Roads Department – Planning Report

Register Reference: SD22A/0286 **Date:** 13-Jul-2022
Development: Demolition of 2 sheds and the construction of 30 dwellings; 1 vehicular and pedestrian link with Main Street, Newcastle; vehicle and pedestrian link with Glebe Square, Newcastle and all associated and ancillary site development works.
Location: Main Street, Newcastle, Dublin
Applicant: Deane and Deane Ltd.
App. Type: Permission
Planning Officer: SARAH WATSON
Date Recd: 24-Jun-2022
Decision Due Date: 18-Aug-2022

Figure 1 road layout from SD00A/0919

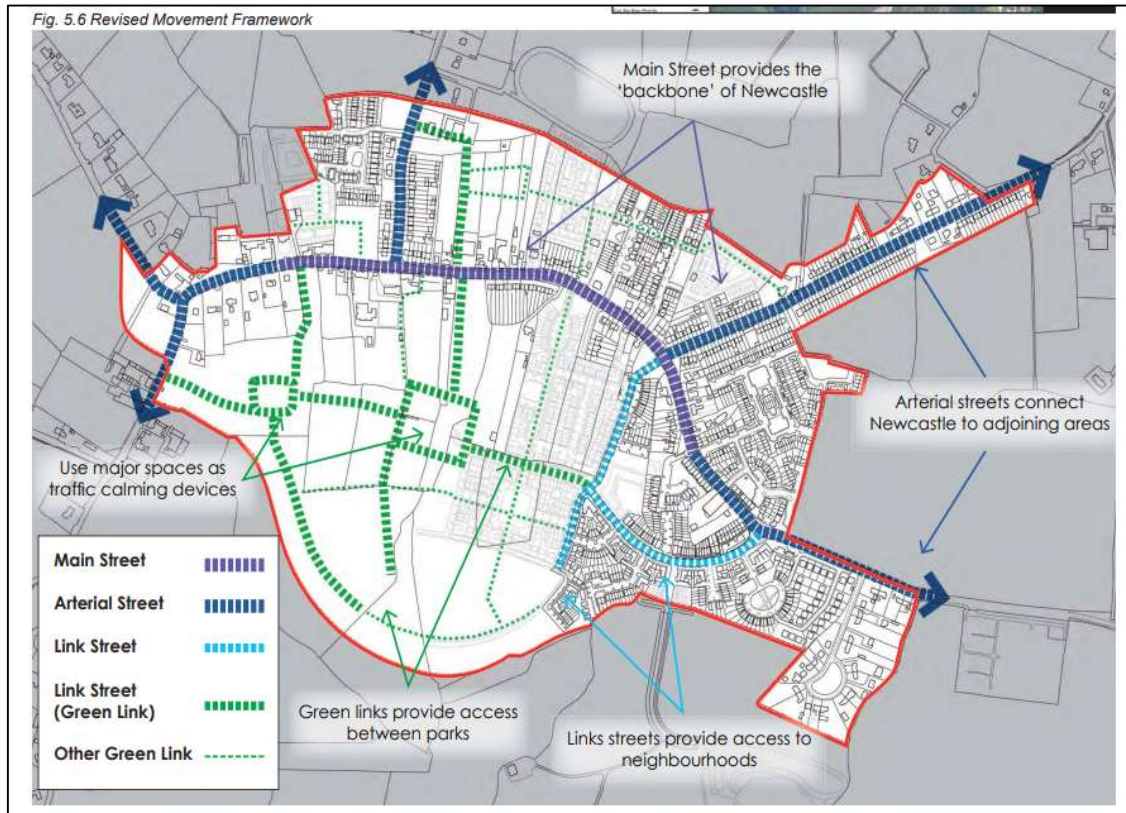
The development has two vehicle access and an additional pedestrian access. The internal roads are link streets and homezones of 5.0m, 5.5m and 6.0m withs. The link road has parallel parking spaces and perpendicular spaces with 6.0m reversing space behind. The development has two vehicular access locations and an additional pedestrian access. The link road through the development to neighbouring Glebe development matches the layout from the 2012 Newcastle LAP. The link to Newcastle Glebe was proposed in a planning application dating back to 2000, shown in Figure 1.
